Product Change Notification

110906 - 01

Change Notification #: 110906 - 01
Change Title: Intel® Desktop Board DH67GD, Boxed and Bulk
PCN 110906-01, Product Material
Replace PWM CONTROLLER
Reason for Revision: Add CPU Socket Cover change
Date of Publication: August 10, 2011

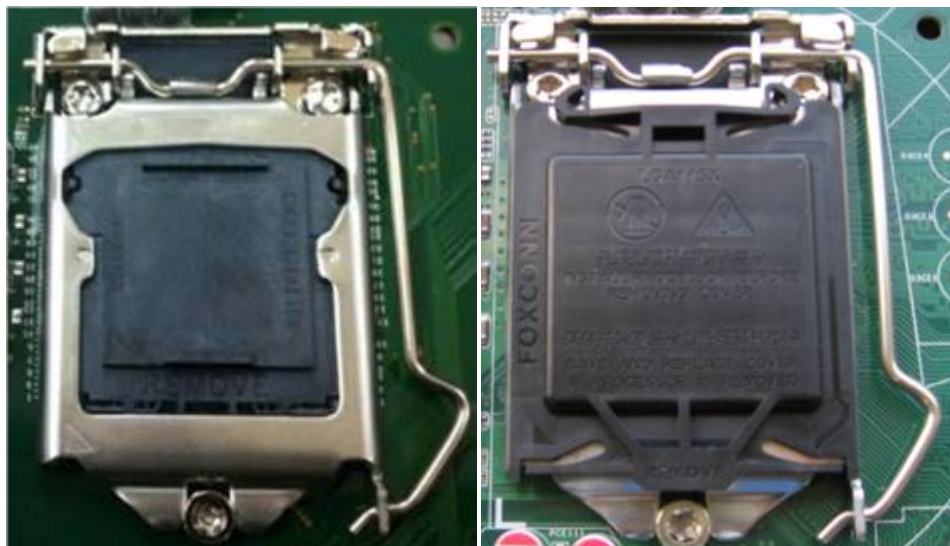
1. The Pulse Width Modulation controller CHIL 8104 upgraded from version E4 to E5 to enhance performance.
2. The CPU socket cover will be changed to the ILM version.

Current socket with PNP cover

New socket with ILM cover
